Product Change Notification / ASER-27XDYP288

CCB 5132.001 Final Notice: Qualification of MTAI as an additional scan and pack site for selected ATTINY814-SSF and ATTINY814-SSN catalog part numbers (CPN) available in 14L SOIC (3.90mm) package.

CCB 5132.001

PCN# ASER-27XDYP288

Tube Comparison – BQM and Pin 1 Orientation

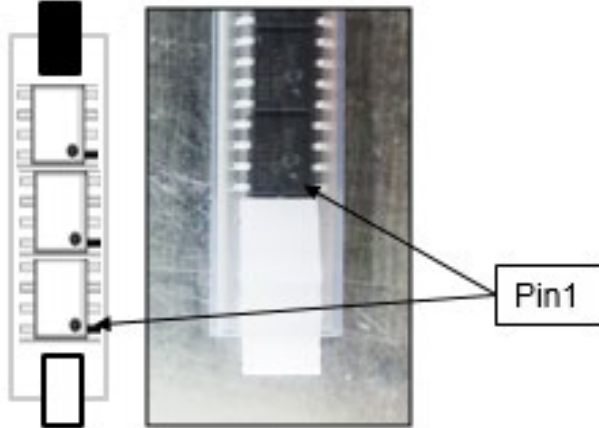
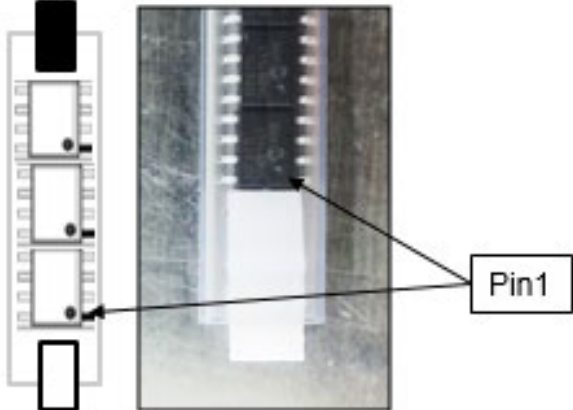
Pre Change	Post Change																
<div></div> <div><table><tr><th>Media</th><th>Unit per Tube</th><th>Pin 1 Side</th><th>Opposite Side</th></tr><tr><td>TUBE</td><td>56</td><td>White</td><td>Black</td></tr></table></div>	Media	Unit per Tube	Pin 1 Side	Opposite Side	TUBE	56	White	Black	<div></div> <div><table><tr><th>Media</th><th>Unit per Tube</th><th>Pin 1 Side</th><th>Opposite Side</th></tr><tr><td>TUBE</td><td>57</td><td>White</td><td>Black</td></tr></table></div>	Media	Unit per Tube	Pin 1 Side	Opposite Side	TUBE	57	White	Black
Media	Unit per Tube	Pin 1 Side	Opposite Side														
TUBE	56	White	Black														
Media	Unit per Tube	Pin 1 Side	Opposite Side														
TUBE	57	White	Black

Pre Change

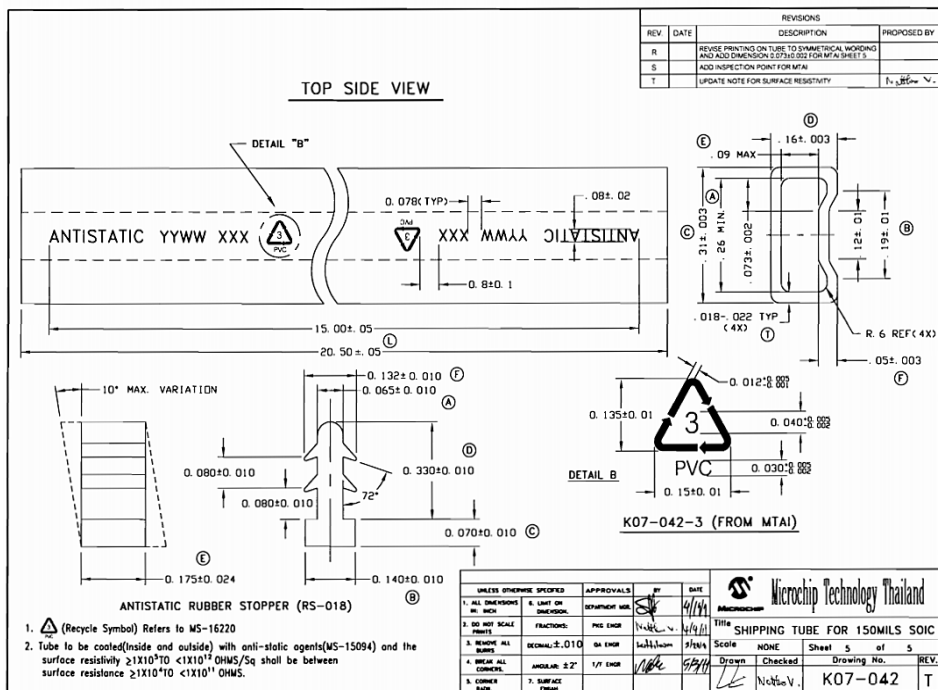
Length	Dimension	Color
20.50 +/-0.05 inch	See on drawing	Clear

Post Change

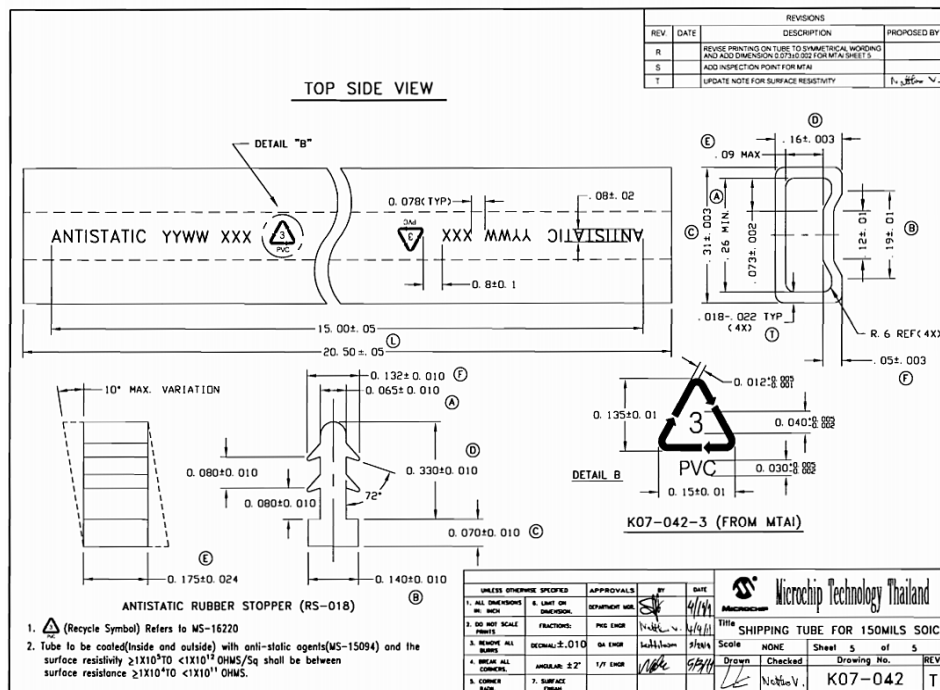
Length	Dimension	Color
20.50 +/-0.05 inch	See on drawing	Clear

Tube Comparison – Packing Method

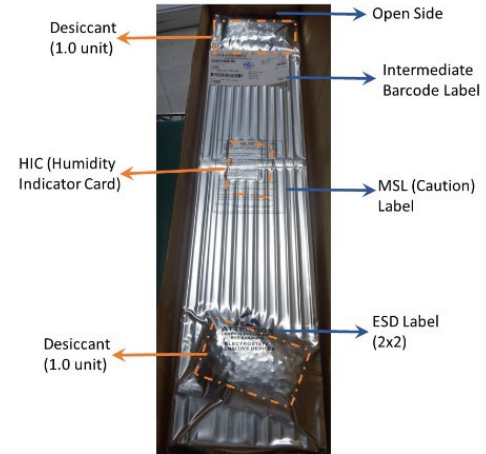
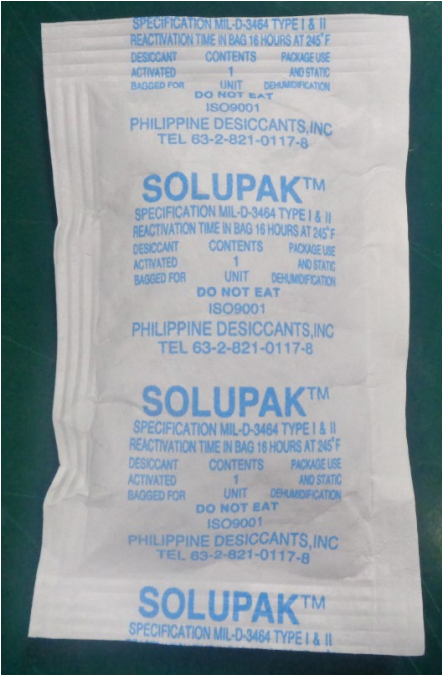
Pre Change

Post Change

P/N	WIDTH	LENGTH
DY3650	160	650
